HISTORIC AND DESIGN REVIEW COMMISSION

HDRC CASE NO: 2017-257
ADDRESS: 219 PEREIDA ST
LEGAL DESCRIPTION: NCB 949 BLK S PT 3 LOT E 59.41 FT OF S 8 FT OF 7 & E 59.41 FT OF 8 & A12
ZONING: RM-4 H
CITY COUNCIL DIST.: 1
DISTRICT: King William Historic District
APPLICANT: Luis Narro
OWNER: Rao Curran Mathuran
TYPE OF WORK: Installation of front yard fence
REQUEST:

The applicant is requesting a Certificate of Appropriateness for approval to construct a new iron front yard fence measuring 4 feet in height.

EXAMPLE FENCING

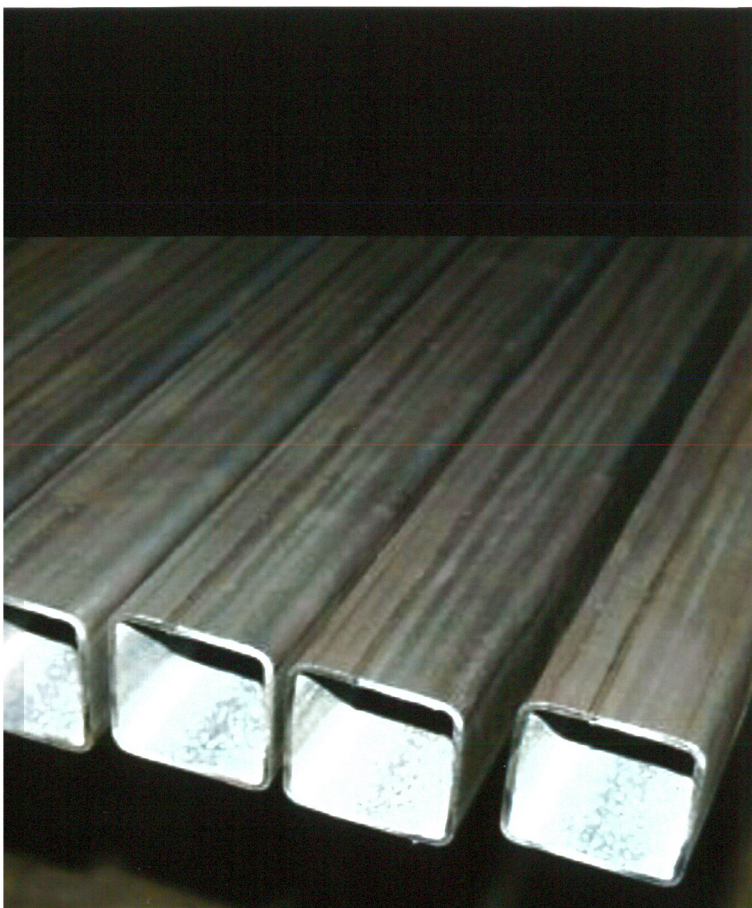
- d. MATERIALITY – The applicant has proposed that the fence be constructed of iron posts with metal panels similar in size and appearance to cattle wire panels. According to guideline 2.B.v, new fences should utilize materials that are similar in scale, texture, color, and form as those used in the district. Fences with posts and wire panels are common in the King William Historic District, but the fences characteristic to the district are constructed of wooden posts versus metal. The posts are also thicker in footprint, typically 3x3” or 4x4”, versus the smaller width of the metal posts submitted in the application. Staff finds the materiality inconsistent with the guidelines and the characteristic fencing of the district as submitted.

Staff recommends approval of the fencing based on findings a through d with the stipulation that the applicant utilizes cedar posts instead of the submitted metal posts to be consistent with the fencing that is characteristic of the King William Historic District. The applicant must submit final drawings and material specifications to staff for approval prior to receiving a Certificate of Appropriateness. The drawings must indicate the final height, depth, and width of all fence elements, including metal panels, cedar posts, and top and bottom rails. The specifications must indicate the specific materials selected for construction, including color and finish, and must match the submitted drawings.
